MEMORANDUM

TO: Nick Senn
FROM: Mike Fowler
DATE: December 21, 2021
RE: **27th Street Underpass – Plan Revisions under Advertisement**

The plans listed below are hereby revised under advertisement due to the elimination of retaining walls 1 and 3 and some minor quantity changes. The boulder walls have been eliminated from the project and the slopes in these areas regraded. The revised plan sheets are attached and a revised Bid Schedule has been provided via email.

27TH ST AND SH82 PEDESTRIAN UNDERPASS 27TH STREET (WEST) UTILITY PLAN			
Engineer:	MDF	Structure Numbers	
Drawn By:	AMC		
Sheet Subset:	UTIL	Subset Sheets:	6 of 11

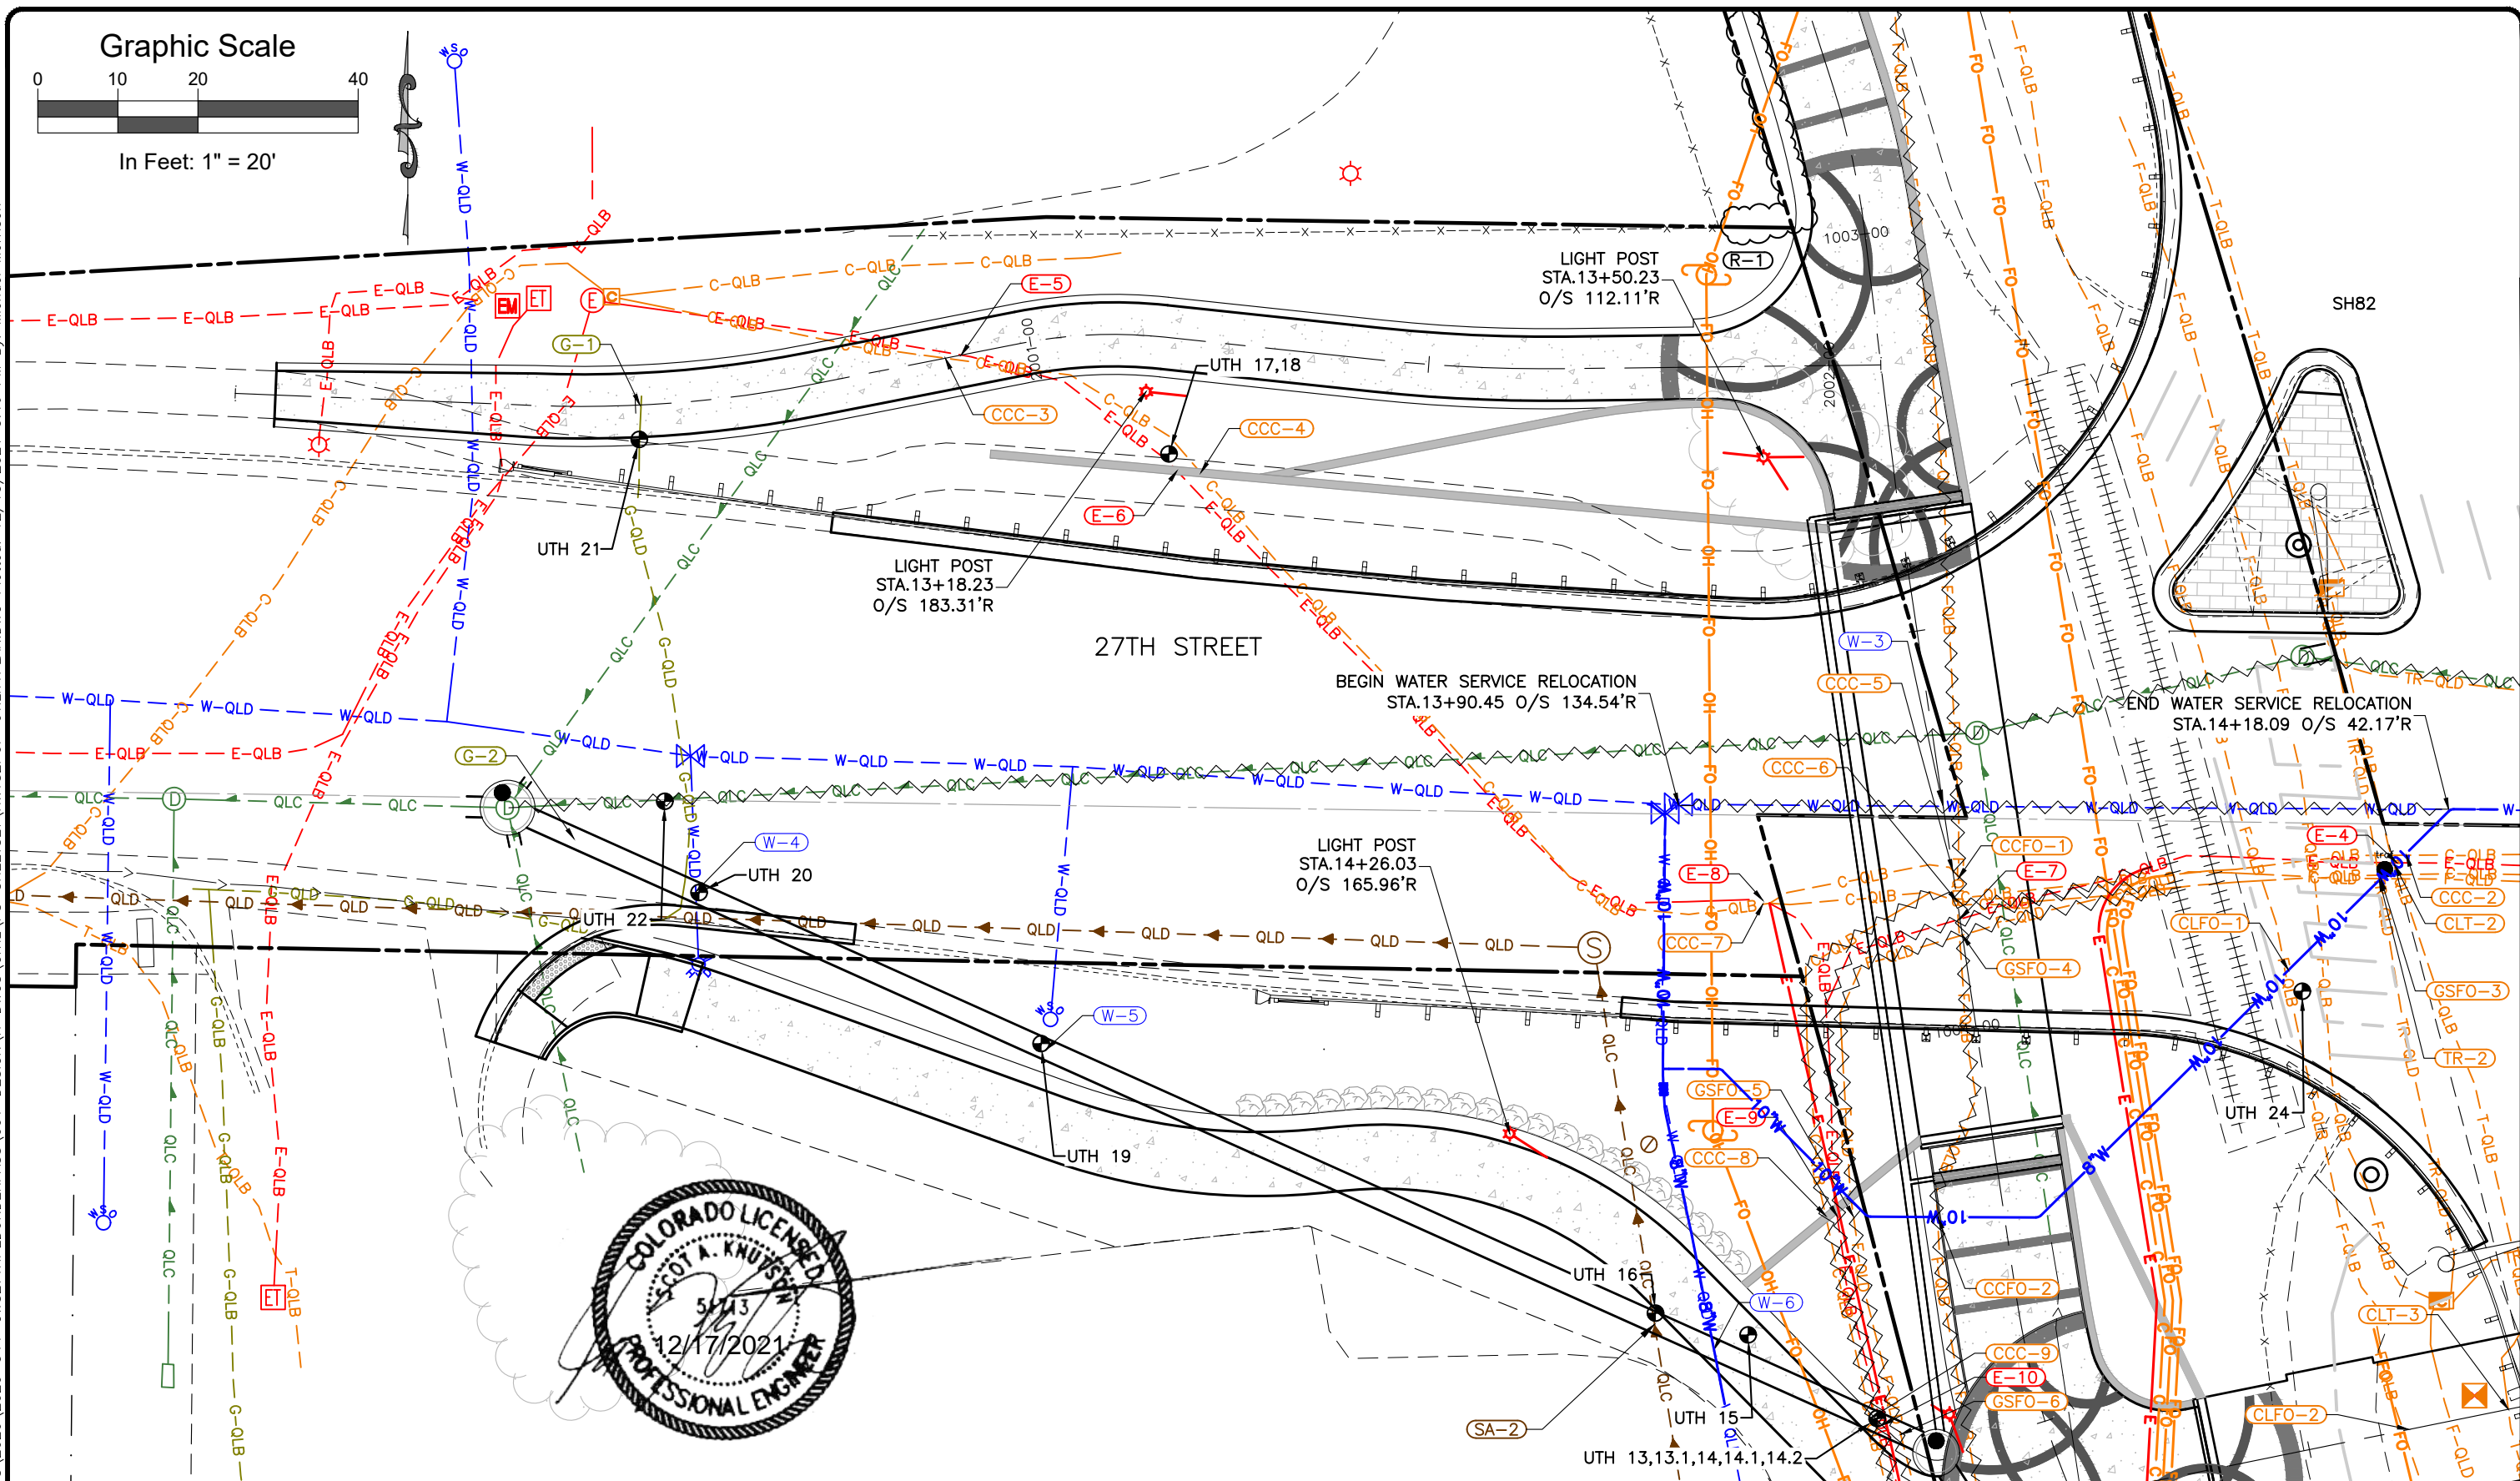
Sheet Revisions			
Rev.	Date	Comments	Init.
1	12/22/21	ELIMINATED WALLS 1&3	MWM

27TH ST AND SH82 PEDESTRIAN UNDERPASS WALL GEOMETRY PLAN (1)			
Engineer:	MCF	Structure Numbers	
Drawn By:	AMC		
Sheet Subset:	WALLS	Subset Sheets:	W06 of 43

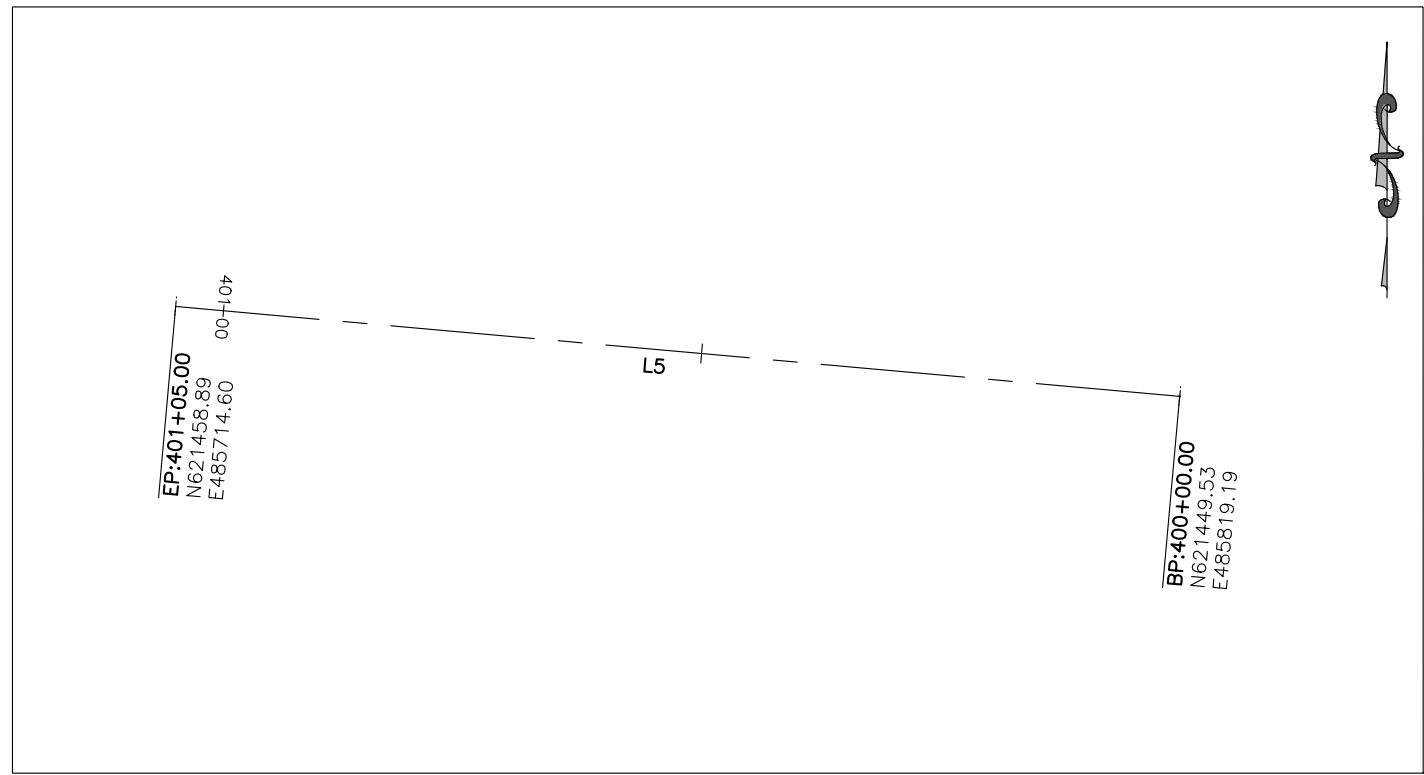
Sheet Revisions			
Rev.	Date	Comments	Init.
1	12/22/21	ELIMINATED WALLS 1&3	MWM

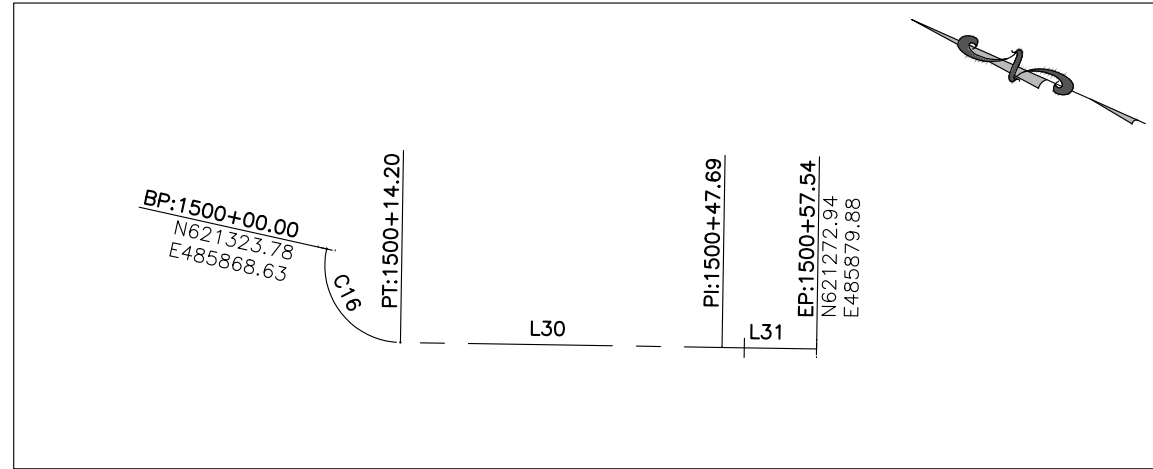
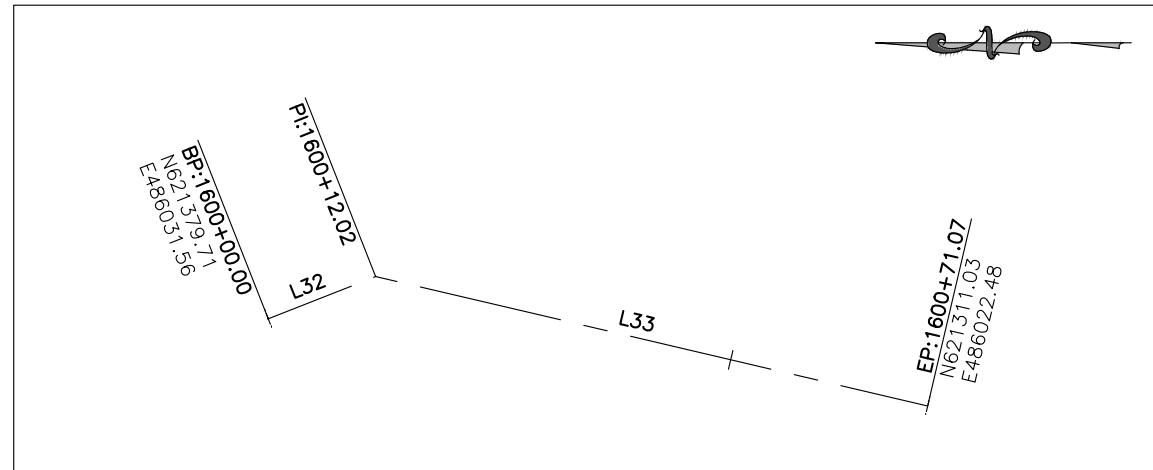
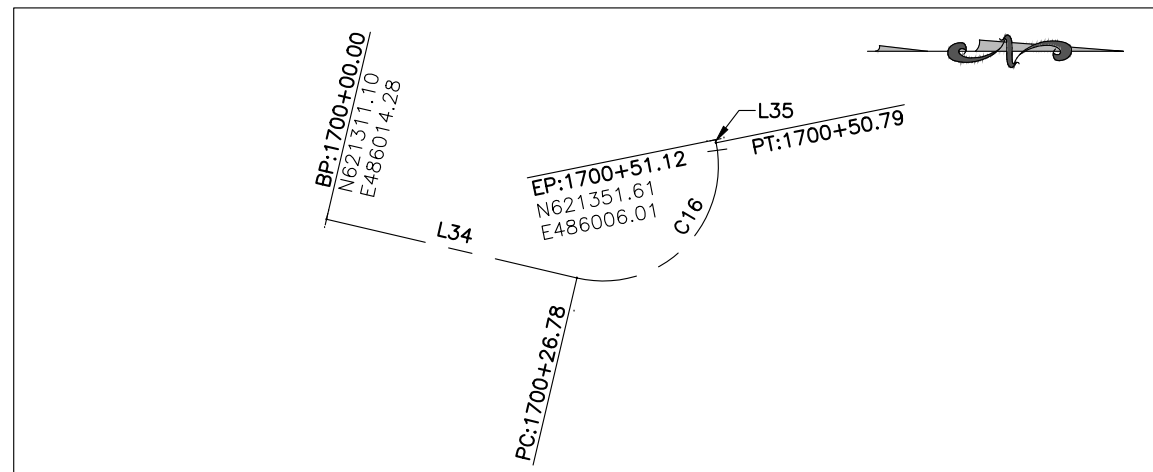
Computer File Information Print Date: 12/15/21 Last Modification Date: 12/15/21 Drawing File Name: Hwy82PUP-WallGeometryPlan Autocad Ver. 2020 Scale: As Shown SGM Project No.: 2020-544.001 Quality Control: MCF		Sheet Revisions <table border="1"> <thead> <tr> <th>Rev.</th> <th>Date</th> <th>Comments</th> <th>Init.</th> </tr> </thead> <tbody> <tr> <td>1</td> <td>12/22/21</td> <td>ELIMINATED WALLS 1&3</td> <td>MWM</td> </tr> </tbody> </table>		Rev.	Date	Comments	Init.	1	12/22/21	ELIMINATED WALLS 1&3	MWM					As Constructed No Revisions: Revised: Void:		27TH ST AND SH82 PEDESTRIAN UNDERPASS WALL GEOMETRY PLAN (4) Engineer: MCF Drawn By: AMC Sheet Subset: WALLS		Project No./Code MTF M535-007 / 008 23687 / 23975 Sheet Number 123	
Rev.	Date	Comments	Init.																		
1	12/22/21	ELIMINATED WALLS 1&3	MWM

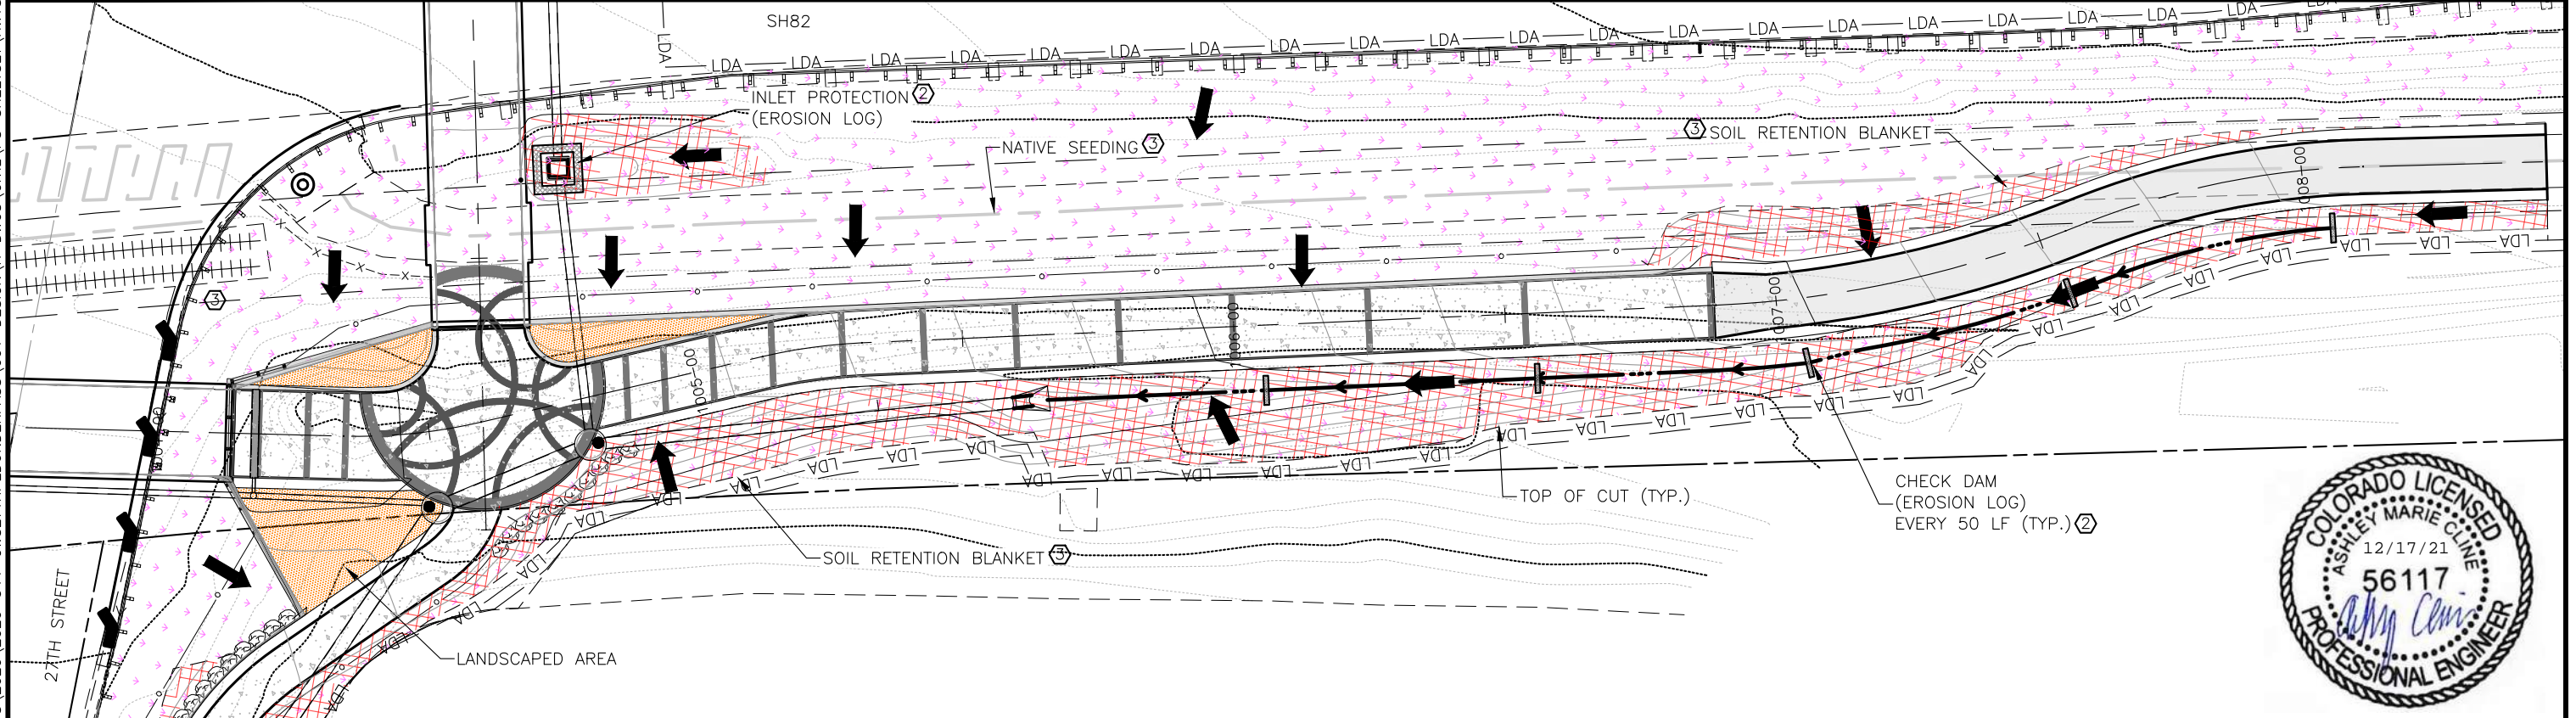
Rev.	Date			Comments	Init.	1	12/22/21	ELIMINATED WALLS 1&3	MWM									No Revisions: Revised: Void:		EROSION CONTROL PLAN (1)		MTF M535-007 / 008 23687 / 23975	
Rev.	Date	Comments	Init.																							
1	12/22/21	ELIMINATED WALLS 1&3	MWM																							
					118 West Sixth Street, Suite 200 Glenwood Springs, CO 81601 970.945.1004 www.sgm-inc.com		Engineer: AMC Drawn By: MWM Sheet Subset: EC		Structure Numbers Subset Sheets: 1 of 3		Sheet Number 197
